Appendix M

ECC/ EODT DNR/NCR Log

Deficiencies and Non Conformance LOG

Figure 1: Detail of Grid 5AD88

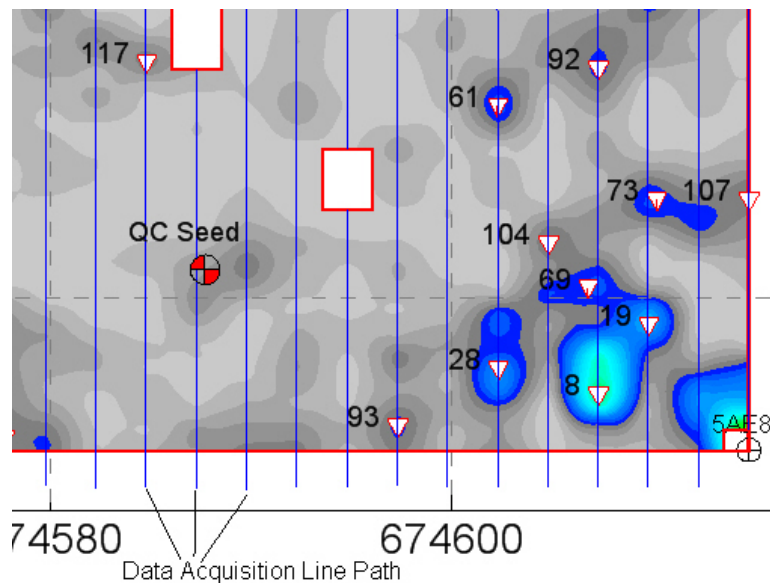
On December 11, 2006 NAEVA's data acquisition Team #4 collected data set 5AD874 which included Grids 5AD87 and 5AD88. On December 21, 2006 ECC's GeoQCS informed NAEVA that a QC Seed Item in Grid 5AD88 was neither sufficiently detected nor targeted. The seed item in question was a 37 mm APT projectile buried 10.5 inches below ground surface in a horizontal (E-W) orientation (approximate location: X: 674587.7, Y:1167341.4 SP NAD 83 AL East U.S. Survey Feet). As part of the root cause analysis process, NAEVA's Geo Lead went to the grid in question to not only gather field information regarding the cause of the discrepancy, but also to verify that the seed item was accurately located by the QC team during its installation. Using the same EM61 MK2 that had originally been used during the geophysical data collection for that grid, the NAEVA Geo Lead determined that the recorded position of the QC seed was accurate.

Using the EM61 MK2 in automatic mode (the method used for reacquisition), the operator was able to achieve a maximum response of approximately 17 mV with the long axis of the instrument oriented north-south. Changing the long axis of the instrument to an east-west orientation reduced the maximum response to approximately 10 mV. NAEVA's field personnel then utilized tape measures and pin flags to reestablish the locations of the north-south lanes used by the data collection team. Segments of four lanes were marked in the field, two on either side of the Seed Item's location. The locations of two trees adjacent to the data collection lanes were confirmed, suggesting that the field data were correctly positioned. The original instrument was then used to replicate the data collection lanes while monitoring its response in the vicinity of the seed item. The maximum observed response was found to be 6 mV above background (peak of 8 mV with a local background of 2 mV).

Because of the seed item's buried depth, its orientation perpendicular to data acquisition paths, and the unclear physical state of the item itself, this blind QC seed item was not targeted by the data analyst. Based on the investigation conducted at this seed location, it is believed that this seed item was likely untargeted due to its very subtle EM response above the surrounding area background. The processed data set for this grid revealed only a 4.7 (channel 2) mV response at the seed location.

Proposed Corrective Action: On January 3, 2007, the untargeted blind QC seed of grid 5AD88 was discussed between NAEVA and the ECC QC team. It was agreed upon by both parties that a deficiency and/or a non-conformance in work effort was not the cause resulting in the untargeted seed item and therefore not a “QC failure”. Because the location of the seed item is only known by the ECC QC team and the NAEVA Geo Lead, it is suggested that this seed location be targeted by the GeoQCS. This action should allow for this blind seed to be successfully recovered by the dig team assigned to excavate this grid as the reacquisition team will be able to establish an above-threshold-mV-response at this target location.

Figure 1: Detail of Grid 2AJ10

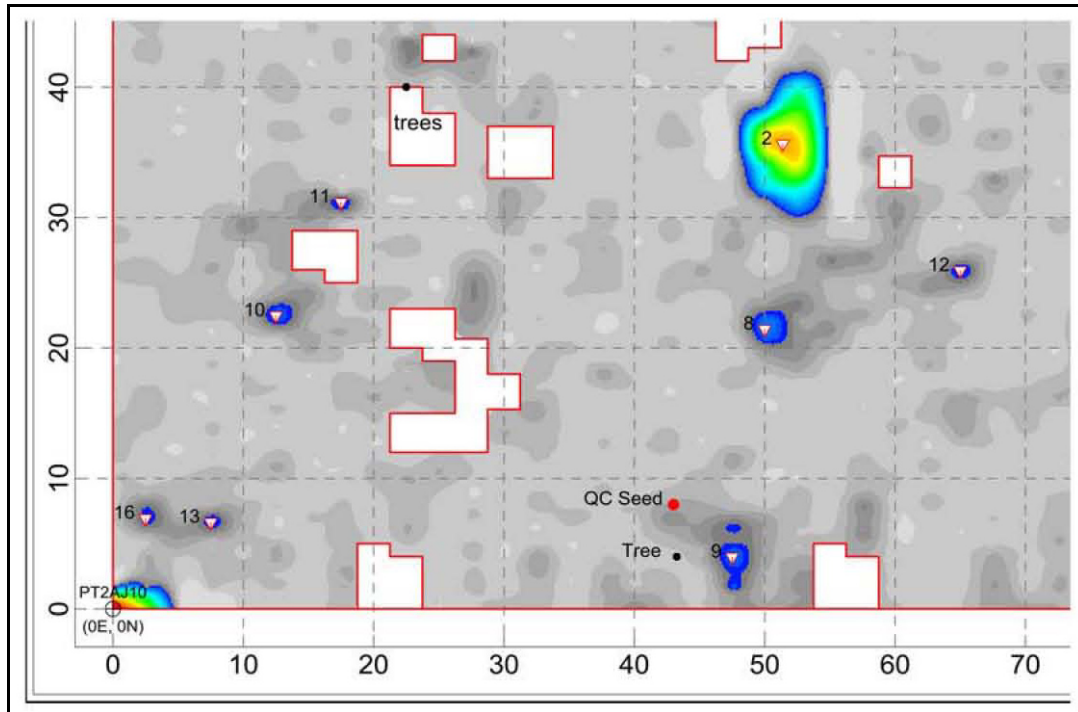
of investigating tree gap locations it was noticed that a 4-5 inch diameter tree was located approximately 4 feet south of the QC Seed in question, and that there was no corresponding gap shown on the contour map. A tape measure stretched along the Grid's southern boundary revealed that the tree was located directly between data collection lines 42.5 and 45 (See Figure 1 below).

During data acquisition, NAEVA's field teams routinely stop data collection whenever an obstruction (i.e. trees) is encountered. Their standard operating procedure is to stop data collection, go around the obstruction, and then continue data collection on the other side of the obstacle. However, in this case, a relatively small tree was encountered directly between two acquisition lanes. Rather than break the acquisition line into separate segments thereby creating a data-gap the geophysical team deviated slightly from the straight lane path on either side of the tree. This relatively small lane variance resulted in the instrument not passing directly over the seed, therefore not attaining sufficient response to generate a target selection. Furthermore, the seed item was oriented parallel to the direction of data collection. Field observations revealed that a change in the EM61's position of 3-4 inches laterally relative to the seed location caused a change in the instrument's response from that of two times the anomaly selection threshold to a response below the anomaly selection threshold.

Proposed Corrective Action #1: Inform and instruct the geophysical data collection teams.

A cursory inspection of processed contour maps reveals that NAEVA's field teams are routinely pausing their data collection for obstructions as is evidenced by the large number of gaps that exist in their geophysical data sets and maps. The geophysical field teams confirmed that deviations such as this are not a common practice, however, data collection judgment calls are made in the field as to the best way to collect geophysical data as dictated by local vegetation, topography and other such factors. On August 8, the discrepancy was discussed with NAEVA's geophysical mapping teams who were shown maps annotated with the seed location, tree location, and line paths. They were instructed that every effort is to be made so that there are no deviations in line path regardless of the size of the obstruction or its position relative to a data collection line.

Proposed Corrective Action #2: Amendment to the intrusive investigation process.

Due the fact that it is physically impossible for the geophysical teams to survey 100% of the grids and areas adjacent to vegetative and topographical features, an amendment to the work plan may be in order in which once all the geophysical anomalies have been investigated in a grid, the intrusive teams will then search a 4 ft radius around each tree to further verify that the grid has been cleared successfully. Although the intrusive teams have been instructed to clear all DGM data gaps and have been doing so since the beginning of the project, this secondary operation is currently not in the work plan; however, it is a viable potential corrective action to this type of explainable discrepancy. This being said, the immediate corrective action may be to modify the work plan accordingly and see if the intrusive / reacquisition teams uncover the seed item.
